REQUEST

Proposed Zoning: UR-2(CD) (urban residential, conditional)

Approximately 9.931 acres located on the east side of Sugar Creek Road, South of Rolling Hill Drive, and north of Tryon Street.

The petition proposes to develop a residential community with up to 200 multi-family units. Starnes Commercial Properties

Figure 11: Driveway Placement from Un-signalized Intersections

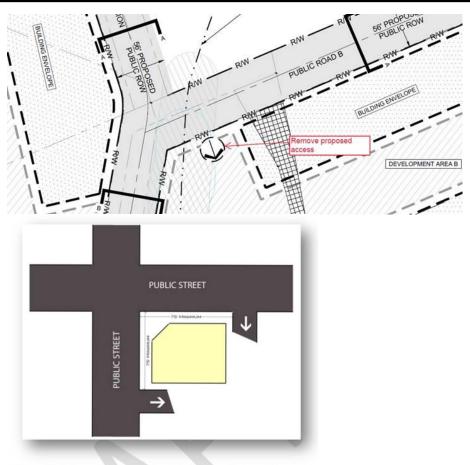
- 10.-Please clarify if parking will occur between the building envelope and street. Addressed
- 11. Site plan and conditional note revisions are needed to remove the proposed driveway, shown below, that does not meet the horizontal driveway spacing requirements from an unsignalized intersection. Alternatively, the petitioner may relocate this proposed access 75-feet from the unsignalized intersection, per Figure 11 of CDOT's Driveway Manual. Addressed
